**Woodstock Conservation Commission  
Development Review Committee  
Date: June 15, 2020**

**RE: Woodstock Valley Country Store expansion project**

1484 Route 171 at intersection of Barlow Cemetery Road.

Approximate location of the  
Woodstock Valley Country  
Story expansion project

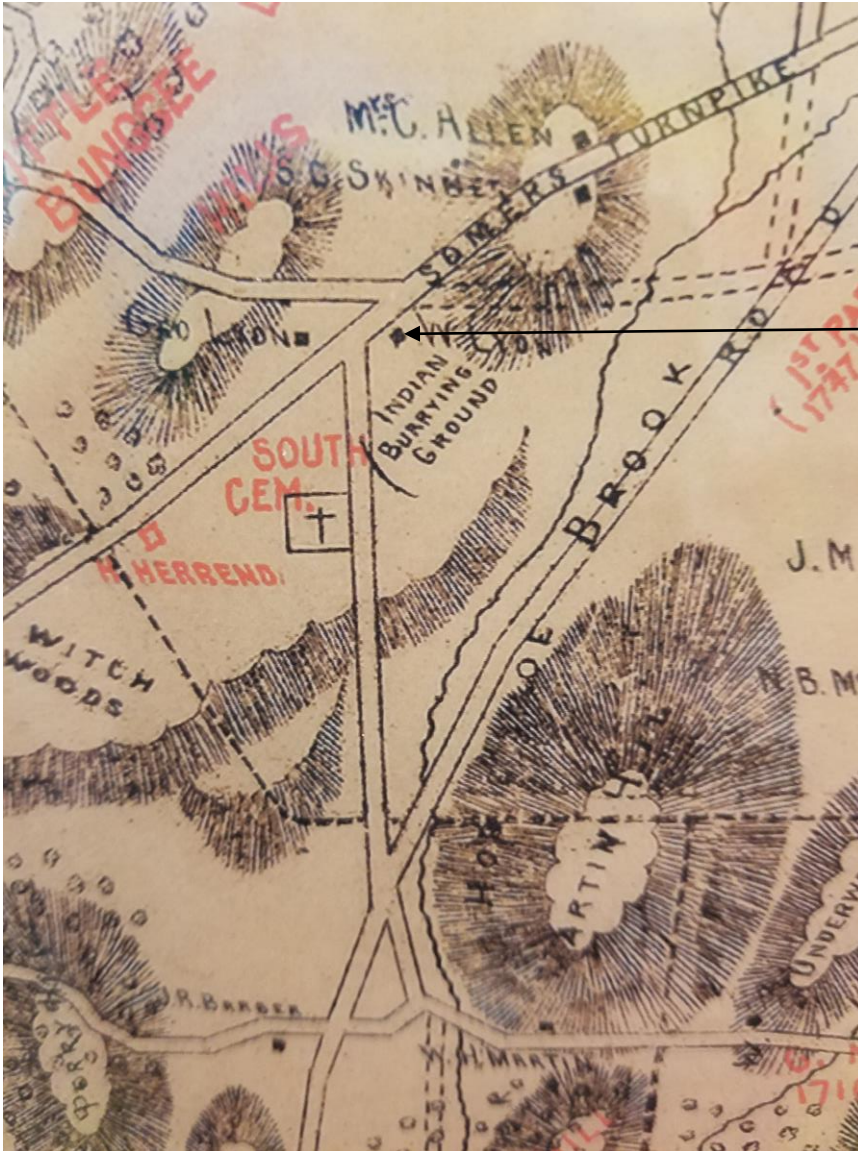
The 1883 map of Woodstock shows a potential archaeological site near this proposed project. While the old map is not suitable for site specific review, and the roadway may have been shifted to its current location, the significance of the site warrants careful review.

4. Consult with the state archaeologist regarding the record of the Indian Burial Ground.
  5. Minimize overnight lighting by use of motion sensor security lighting in every feasible location that lighting is proposed.
